VSP-35  
April 21, 1982

Global Navigation Service Bulletin No. 21  
(Highly recommends modification to the  
battery charging card which is installed in  
Optional Equipment Unit P/N 10600-2-2XX.)

## MODIFICATION OF BATTERY CHARGING CARD P/N 11745-1

Number 0021

Figure 1 (Sheet 1)

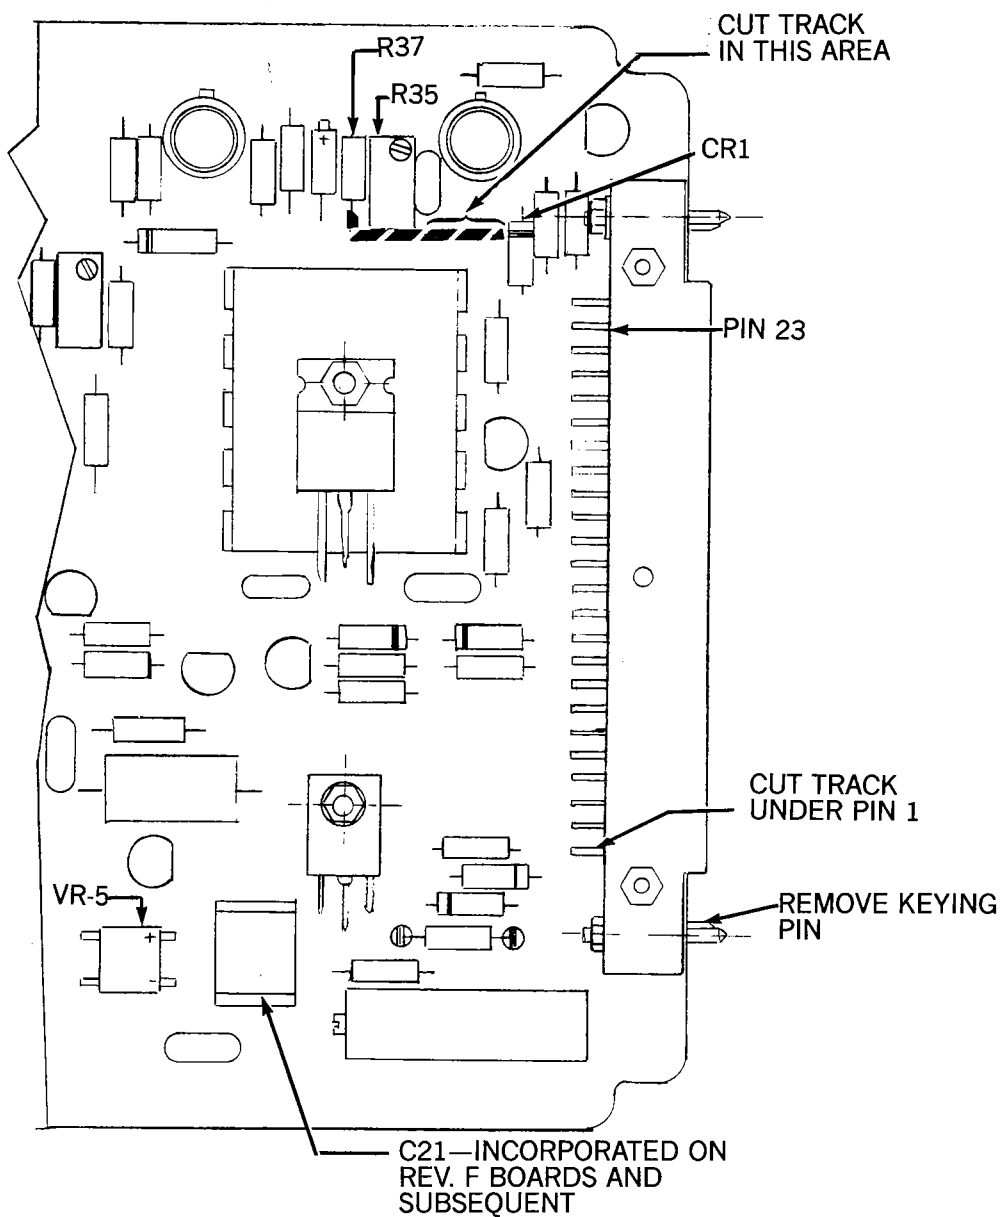
- (1) Remove top cover from OEU P/N 10600-2-2XX.
- (2) Remove battery charging card P/N 11745-1 from Slot J2 in OEU.
- (3) Perform the following impedance check using a digital multimeter with a minimum input impedance of 10 Megohms.
  - (a) Connect positive lead to Pin 1 on connector. See Figure 1 (Sheet 1).
  - (b) Connect negative lead to Pin 24 (ground). See Figure 2.

- (c) Check potentiometer R35 for resistance value. Resistance value may either be 20K ohms or 2K ohms. See Figure 1 (Sheet 1).

- (4) Remove keying pin from connector at end adjacent to Pin 1. See Figure 1 (Sheets 1 and 2).

- (5) Cut tracks at location A (under Pin 1) and at location B (on track near R37) with an Exacto knife or equivalent. See Figure 1 (Sheets 1 and 2).

- (7) Perform continuity check between the following and verify that the circuit is open. See Figure 1.

Figure 2

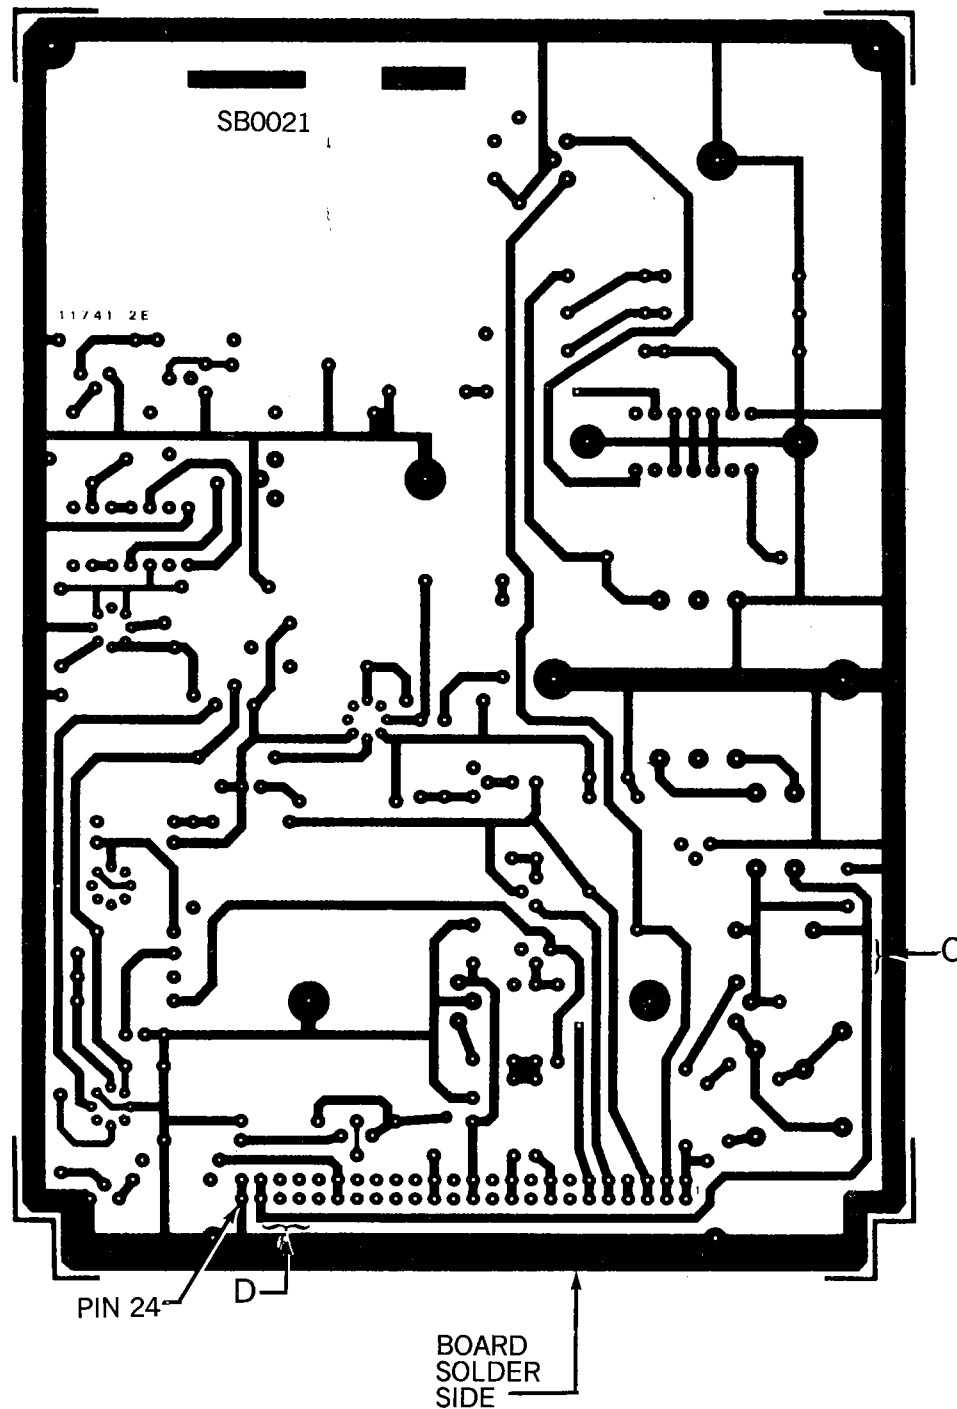
- (6) On solder side of board, cut tracks at locations C and D, removing at least 0.050 inch of track at each location. See Figure 2.

Figure 3

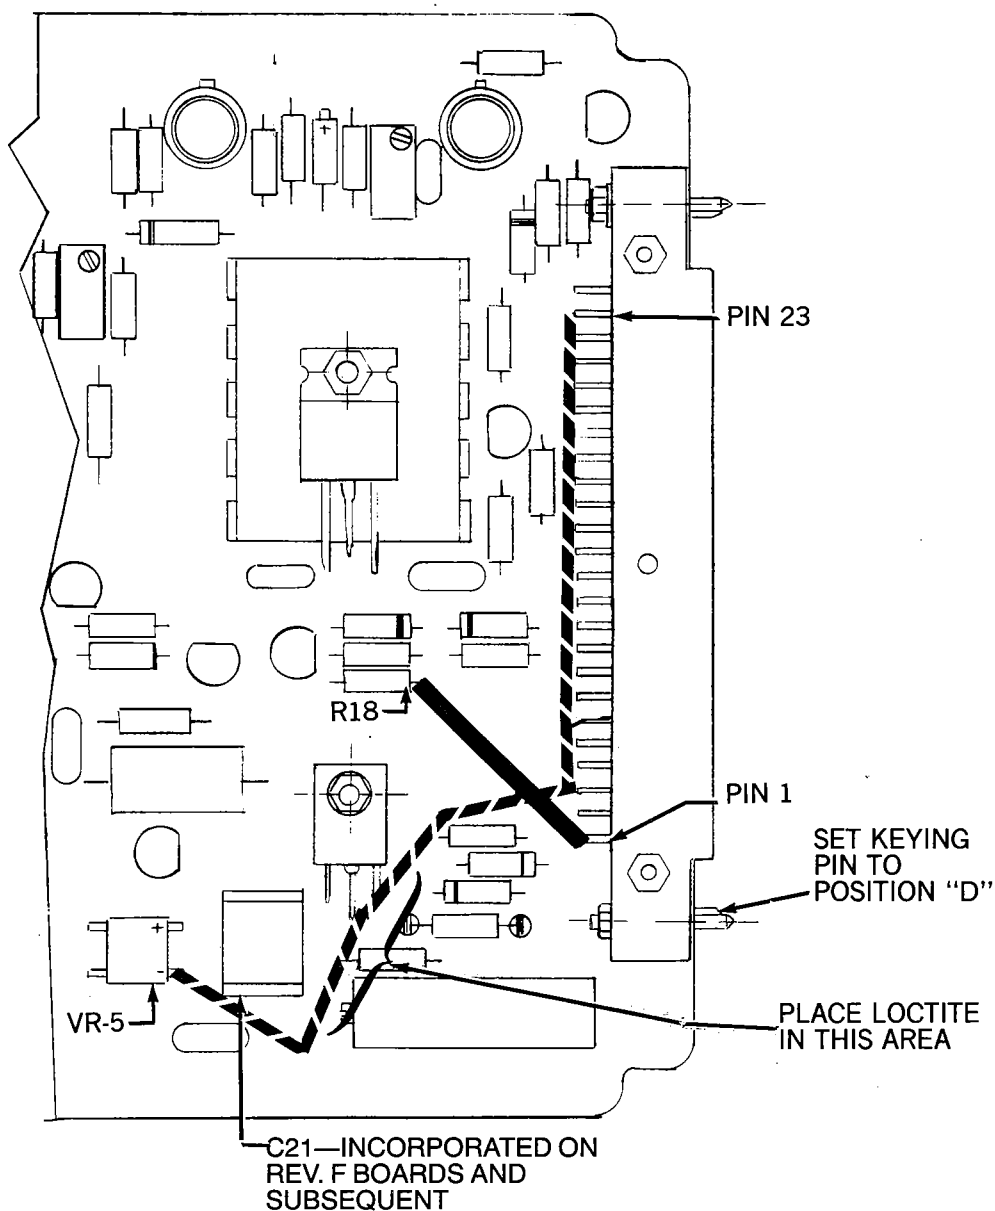
- (8) Solder a 4 inch, 22 gage bus wire covered with teflon sleeving between Pin 23 and negative terminal on VR-5. Trim and dress wire to look neat. See Figure 3.

- (9) Solder a 1.25 inch 22 gage bus wire covered with teflon sleeving between Pin 1 on connector and resistor R18. Trim and dress wire to look neat. See Figure 3.
